Request of Class II Permissive Change

Company name: Harman International Industries, Inc.

FCC ID: APIJBLGO2H

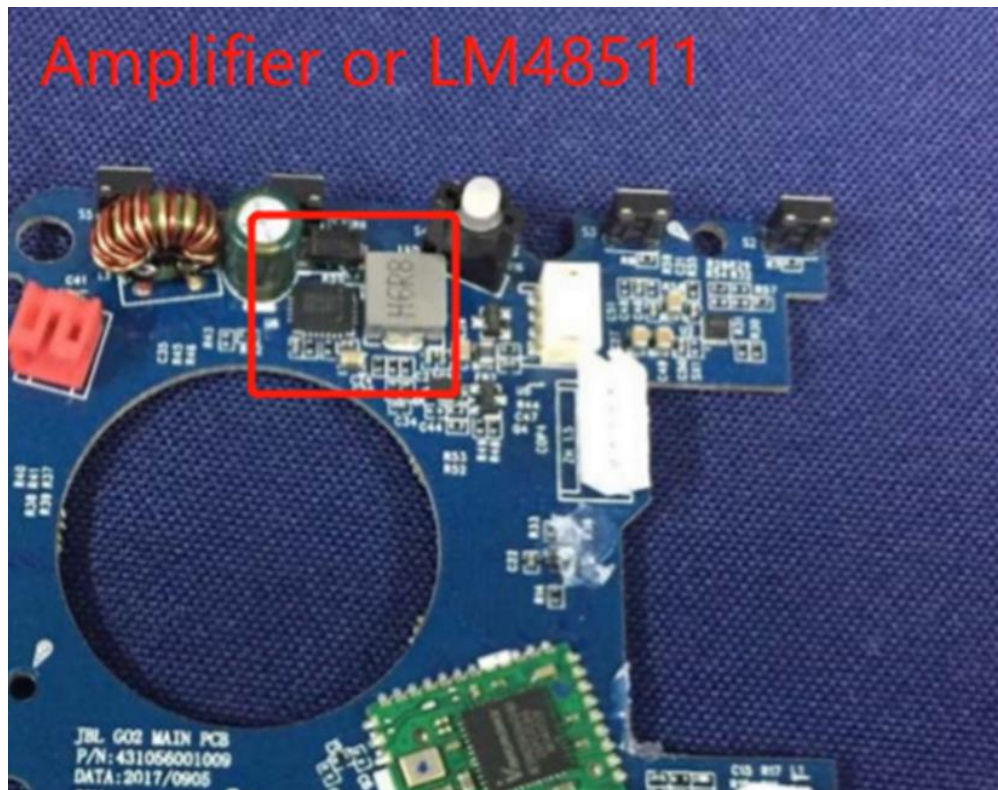
The major change filed under application is:

Compared with the original case, it changed the audio amplifier IC (Amplifier_HT862E) and added battery (304055), this change doesn't influence the RF performance.

Amplifier_ HT862E:

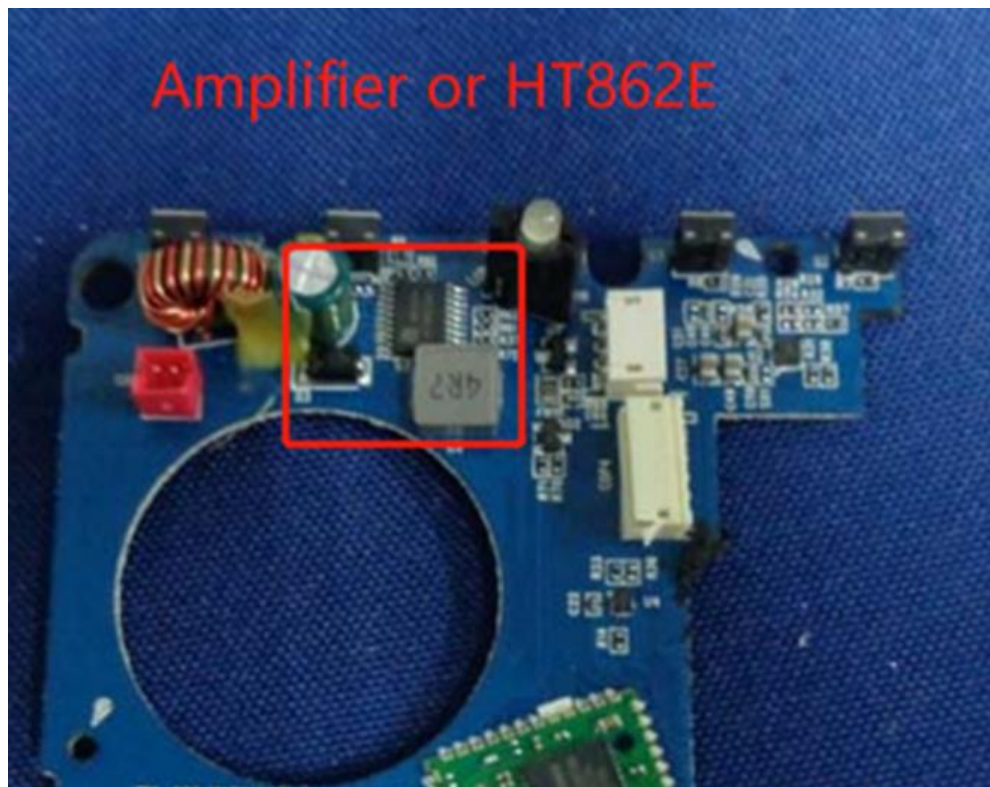
Audio Amplifier IC		Model
	Original case	LM48511
	New	HT862E

Audio Amplifier IC:

Built-in Battery: GO2/MLP284154:

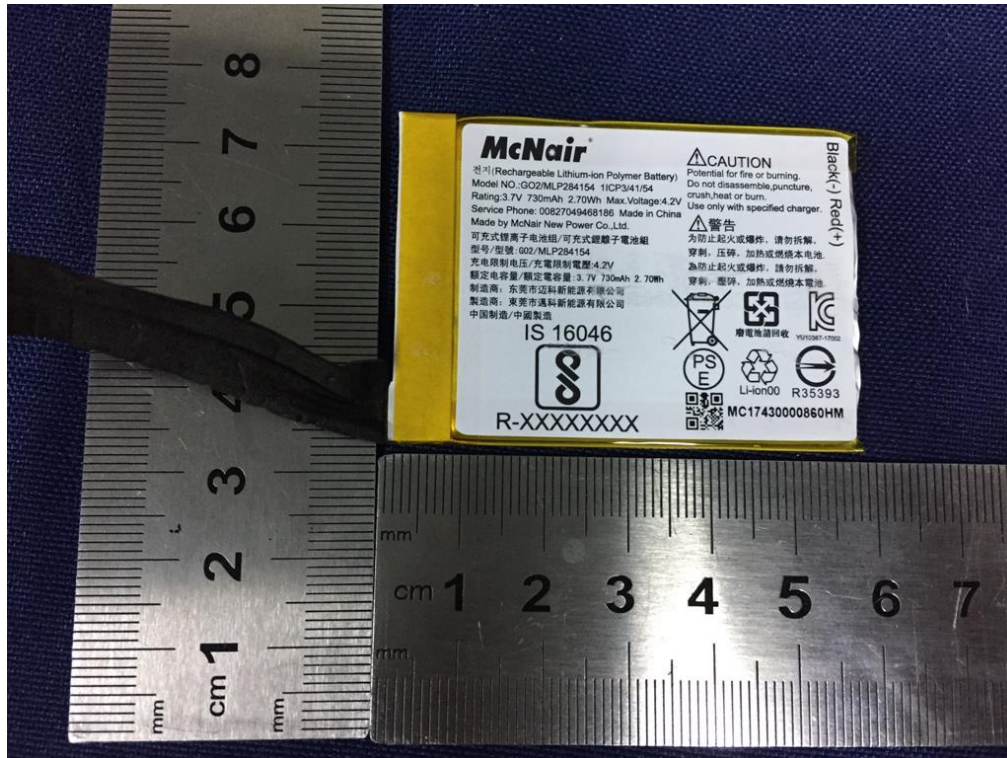
Battery		Manufacture	Model
	Original case	McNair New Power Co., Ltd	GO2/MLP284154
		EVE Energy Co., Ltd	L0707-LF
New	Springpower Technology (Shenzhen) Co., Ltd.	304055

Battery:
